Subject: Reply to Notice of Violation (EA-20-066)

Reference: Notice of Violation (NRC Inspection Report No. 07201015/2020-201 September 3, 2020 ("IR")), dated December 21, 2020; Division of Fuel Management

## **NAC REPLY TO NOTICE OF VIOLATION (EA-20-066)**

Enclosure to ED20210007  
APPENDIX B  
Summary of CC5 design change, licensing basis tip-over methodology, and 72.48

### What is the Licensing Basis Method of Evaluation for Tip-over?

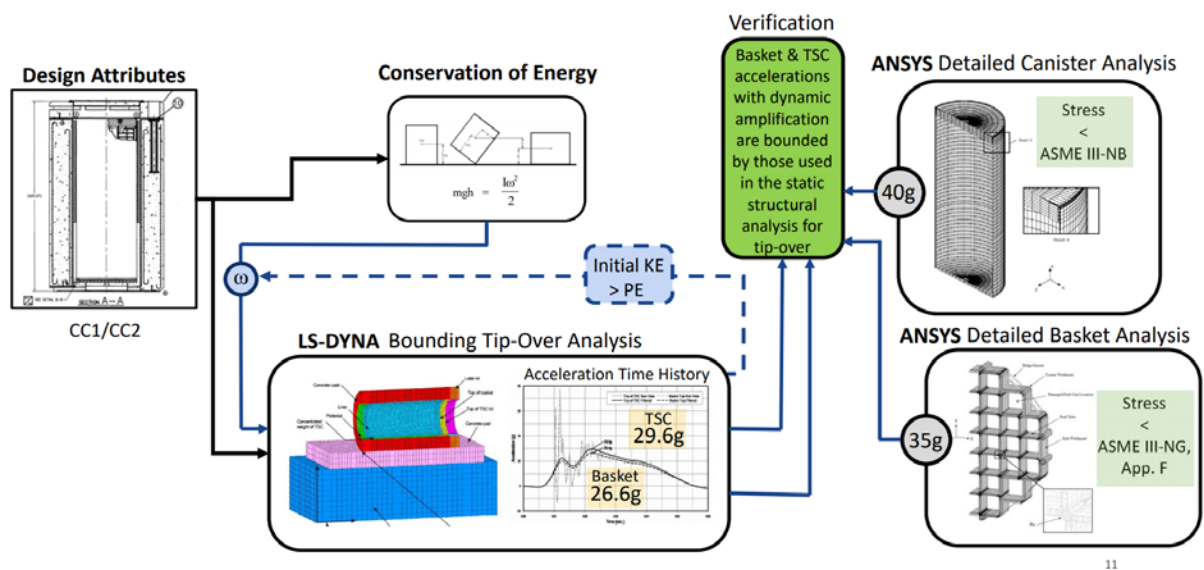
The MOE for tip-over is a 3-step process: (PEC Slide 11)

- Using conservation of energy to determine the angular velocity prior to impact of the cask on the ISFSI pad based on its maximum potential energy.
- Using LS-DYNA to determine the deceleration g-loads the cask experiences resulting from impact with the ISFSI pad defined in the FSAR.
- Calculating the structural stress levels in the canister and basket with ANSYS using impact accelerations which bound the LS-DYNA results
